# HISTORIC AND DESIGN REVIEW COMMISSION

August 17, 2016

**HDRC CASE NO:** 2015-024  
**ADDRESS:** 155 - 161 E COMMERCE ST  
**LEGAL DESCRIPTION:** NCB 106 BLK LOT 32  
**ZONING:** D HS RIO-3  
**CITY COUNCIL DIST.:** 1  
**LANDMARK:** Fishmarket Building  
**APPLICANT:** Crockett Urban Ventures  
**OWNER:** 155 E Commerce Hotel, LLC  
**TYPE OF WORK:** Final approval of landscaping and façade arrangement  
**REQUEST:**

1. Landscaping at the River Walk level.
2. The façade arrangement of the River Walk, street and second levels on the River Walk, N St Mary's and E Commerce facades.

Description  
ENLARGED ELEVATIONS - PODIUM NORTH & EAST

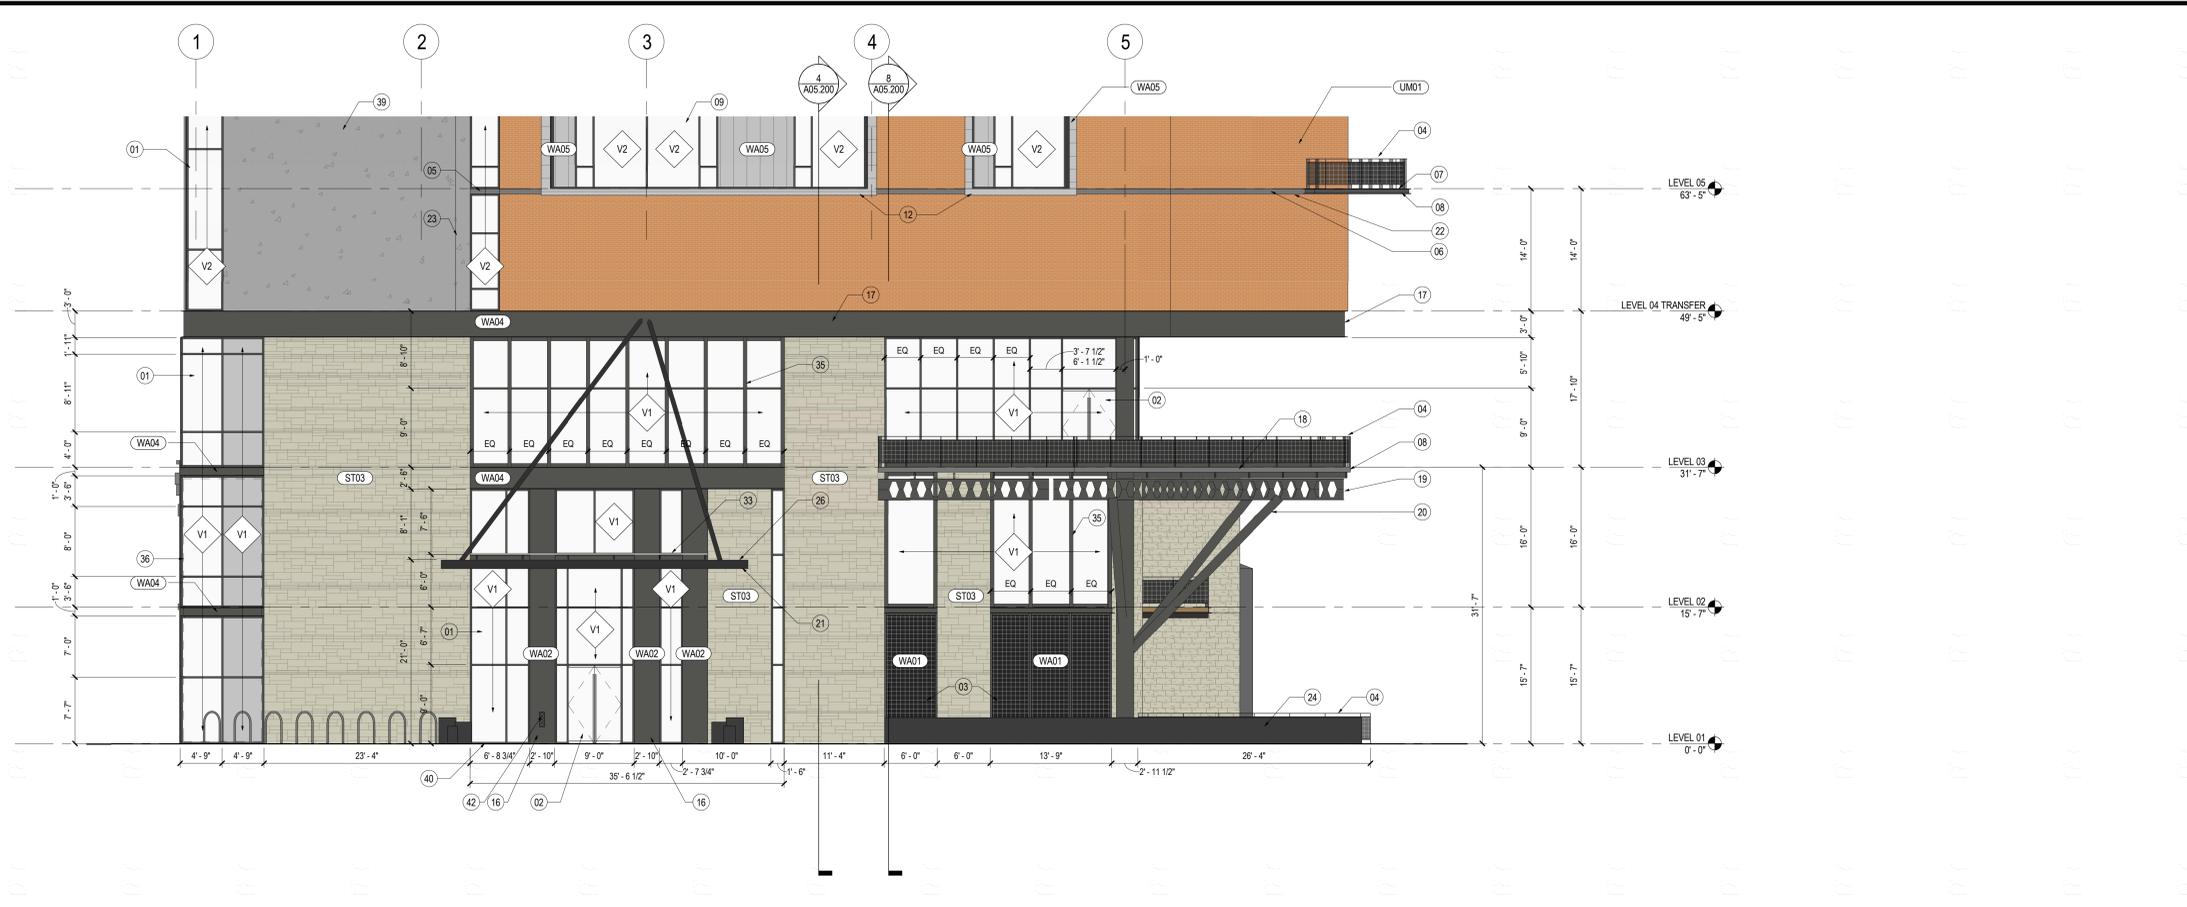
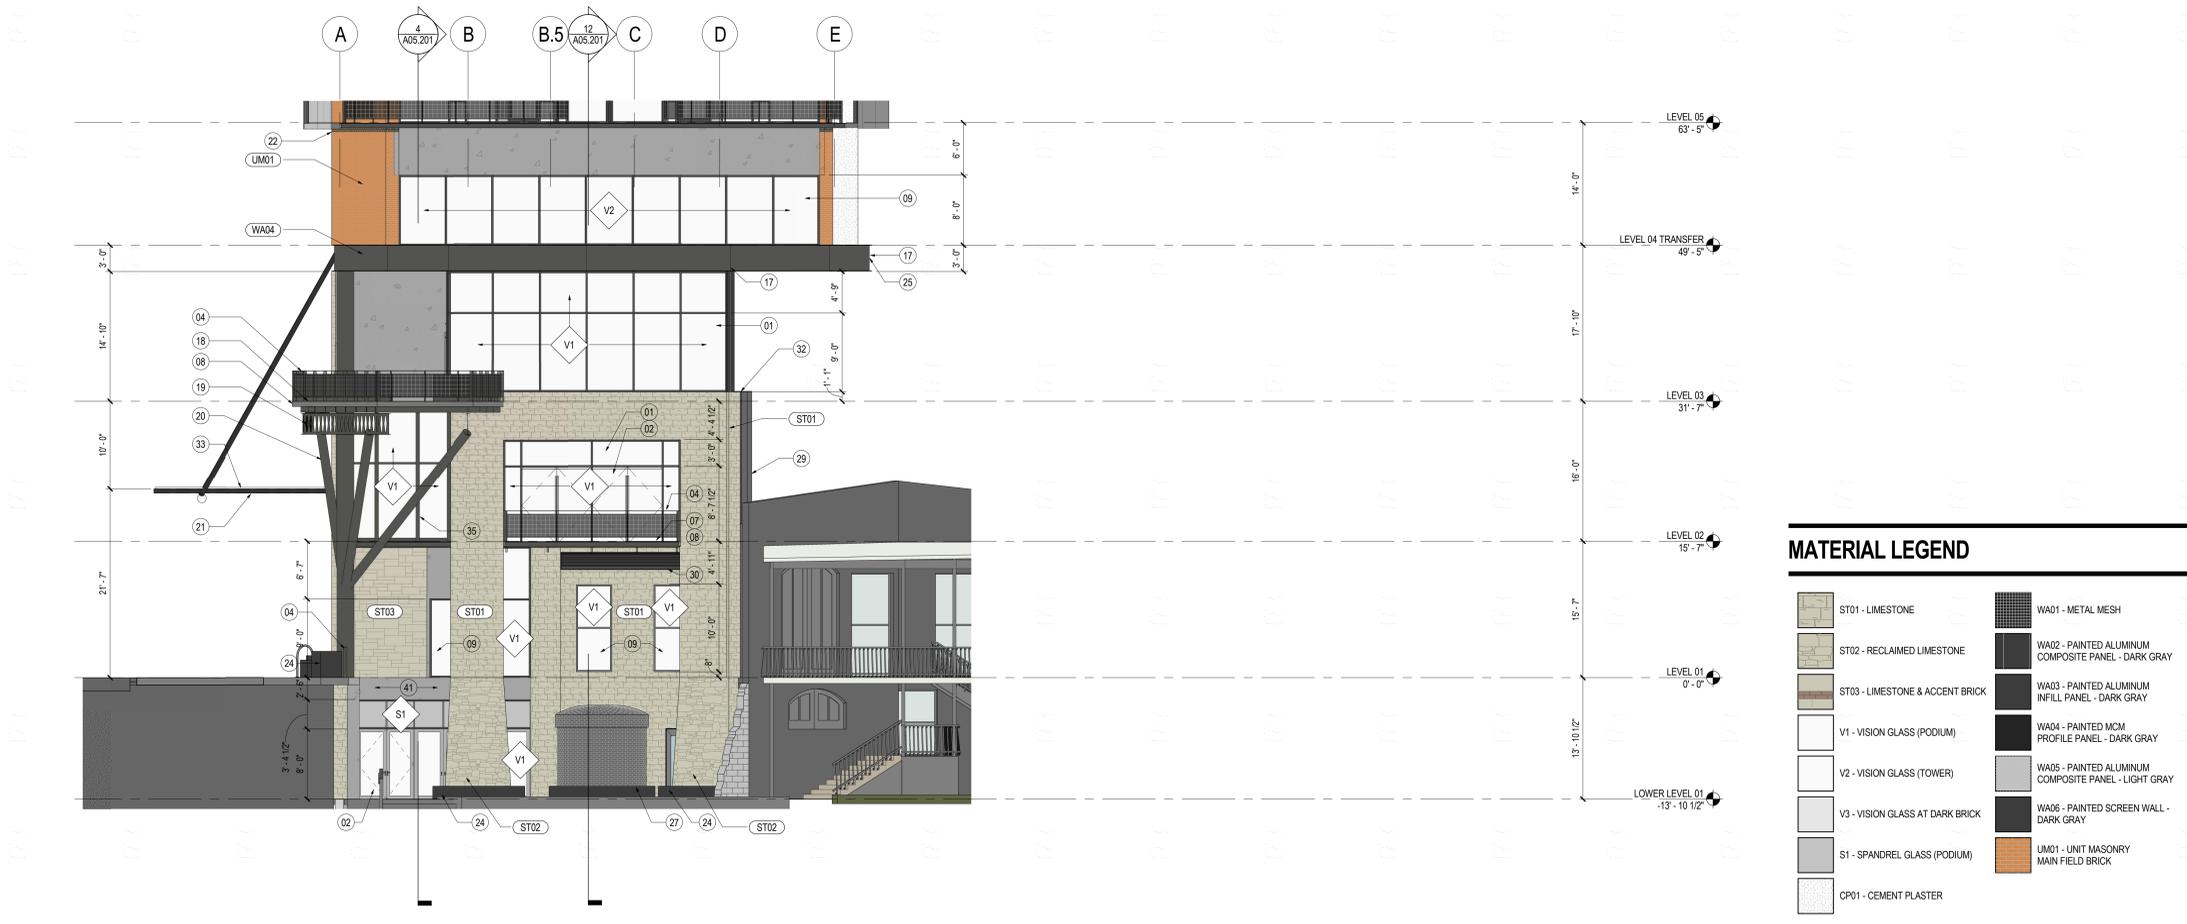
- b. This request was reviewed by the Design Review Committee on July 26, 2016, where committee members commented on the proposed landscaping plan, questioned the relationship between stone cladding of the proposed new construction and the neighboring historic structure. They also recommended the applicant coordinate with the Center City Development and Operations Department in regards to appropriate and manageable plant materials.

- l. FAÇADE ARRANGEMENT and PEDESTRIAN CIRCULATION – The applicant has provided updated information regarding façade arrangement for the proposed new construction in relationship to the adjacent historic structures. Commerce Street consists primarily of storefront facades at the street level. At the corner of N St Mary's and E Commerce, the applicant has proposed a glass curtain wall system. To the immediate west of the proposed curtain wall system, the applicant has proposed a limestone wall featuring approximately forty-six (46) feet in height with no fenestration. Given this wall's location between the street corner and the Dwyer Building, staff finds more visual interest is needed to enhance the pedestrian experience. The applicant should incorporate fenestration or some other element instead of a solid wall at the street level on Commerce. This is more consistent with the existing streetscape and downtown character.

RECONSTRUCTION:  
DWYER BUILDING FACADE

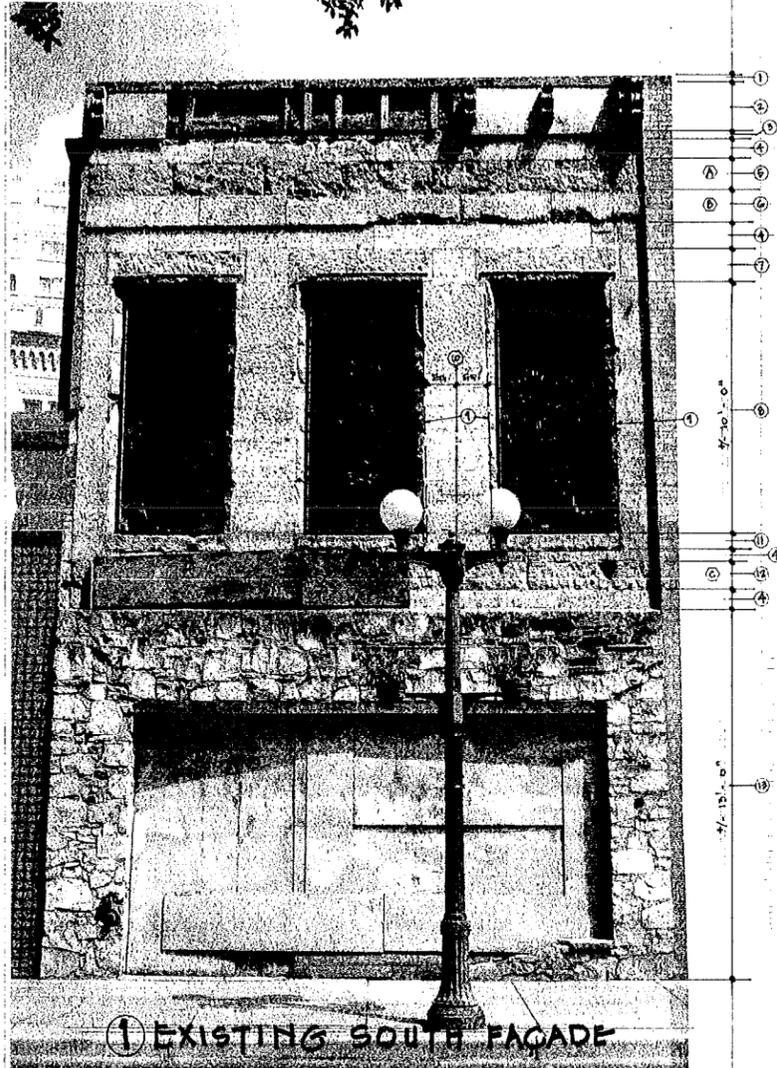
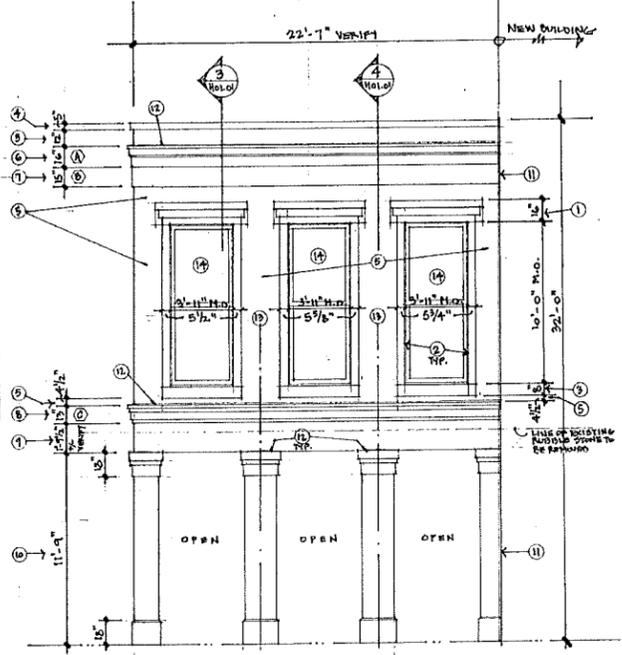
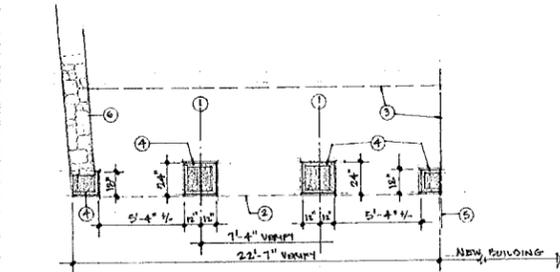
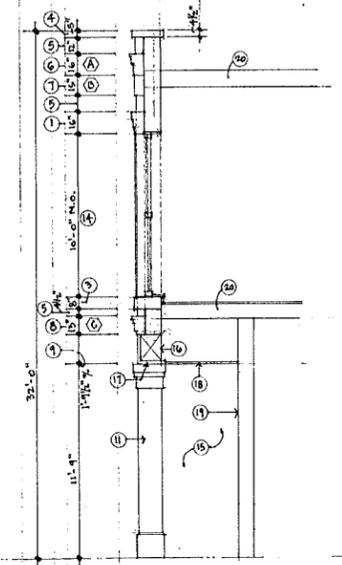
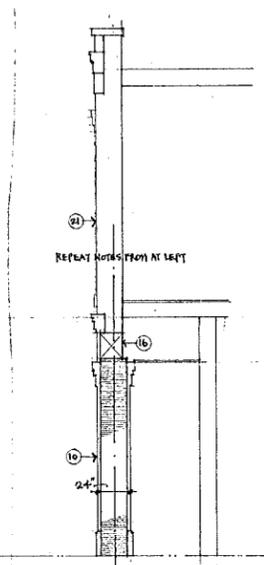
The applicant has noted that the removal of the corner building (Mortgage Investment Company) will include the demolition of the dividing wall which currently not only divides it from the Dwyer Building, but also braces the Dwyer Building's façade. At the time of exterior modifications in 1979, the original ground level façade of the Dwyer Building was modified and replaced with the current, non original rough cut stone. The applicant has proposed to remove the existing façade materials in order to repair and redress the historic stone as well as fabricate window sills, heads and belt courses that will be recreated as dutchmen and inserted into the stone façade. In order to facilitate a proper bond and installation, the applicant has proposed to complete this work off site. Off site work will include the redressing and repair of the existing stone as well as the creation of dutchmen.

3. The production of an elevation with each piece of stone numbered that corresponds to a photograph of each piece of stone. The applicant has noted that this drawing and documentation will be provided by the stone mason.
4. The production of dutchmen samples by the applicant/stone mason prior to production and installation to ensure the quality and character of the landmark will not be jeopardized.
